Access Compliance Report Public Rights-of-Way (Curb Ramps)

Main Street: ESENCIA_DR Cross Street: ESENCIA_DR Location: SE

ADA ID: RPRK220225195531 Ramp Type: Type 6 - Directional 1 Initial Pass/Fail: Pass Overall Compliance: No Severity Score: 6

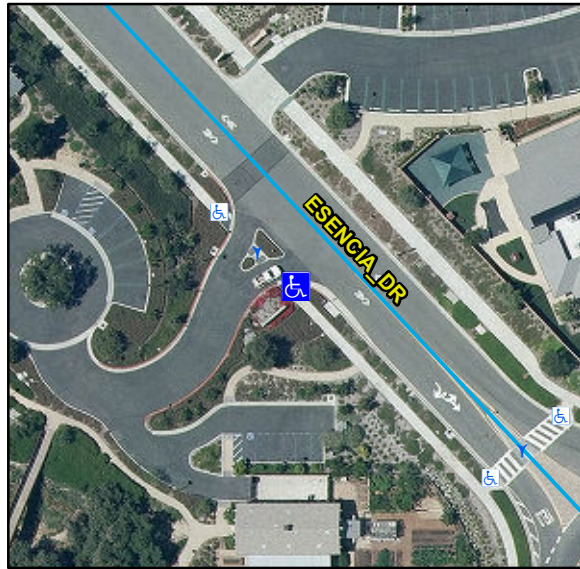
Compliance	Description	Data	Compliance	Description	Data
N/A	Ramp Length (in)	130	N/A	Flare Type LT	
Yes	Ramp Width (in)	60			Sloped
Yes	Ramp Run Slope (%)	6.1	N/A	Flare Slope LT (%)	11.4
Yes	Ramp Cross Slope (%)	1.3	N/A	Flare Traversable LT	No
Yes	Grade Break	Yes	Yes	Flare Type RT	
Yes	Grade Break Slope (%)	1.7			Curbed2
Yes	Grade Break Cross Slope (%)	0.2	N/A	Flare Slope RT (%)	N/A
	Addl Para Ramp Left?	N/A	N/A	Flare Traversable RT	N/A
	Addl Para Ramp Right?	N/A	Yes	DWS Provided	Yes
N/A	Landing Present	Yes	Yes	DWS Contrast	Yes
Yes	Landing Length (in)	58	Yes	DWS Length (in)	33
Yes	Landing Width (in)	60	Yes	DWS Full Width	Yes
Yes	Landing Run Slope (%)	1.4		DWS Offset Type	Single
Yes	Landing Cross Slope (%)	1.4	Yes	DWS Left Offset (in)	0
N/A	Landing Movement Obstructed?	No	N/A	DWS Right Offset (in)	N/A
	Landing Movement Type	N/A			
N/A	Landing Shared	No			
N/A	Marked Crosswalk 1	No	N/A	Clear Space	N/A
	Crossing 1 Direction	SW	N/A	Clear Space To Crosswalk (in)	N/A

Marked Crosswalk 1 Width (in)	N/A			
N/A	Ramp Inside Crosswalk 1	N/A			
	Crossing 1 Slope (%)	0.3			
	Crossing 1 Cross Slope (%)	0			
Yes	Gutter Ponding	No	Yes	Curb Slope	0.2
Yes	Gutter Lip Height (in)	0		Road Run Slope (%)	N/A
No	Gutter Run Slope (%)	5.5		Road Cross Slope (%)	N/A
Yes	Gutter Cross Slope (%)	0.8		Parallel Ramp Side	N/A
Yes	Overall Surface Condition	Acceptable	Yes	Perp Joint Present	Yes
	Cross Gutter Present?	No		Spandrel Present?	No
	Replace Cross Gutter?	N/A		Replace Spandrel?	N/A

Remove & Replace Gutter.

R304.5.4, STD 1115
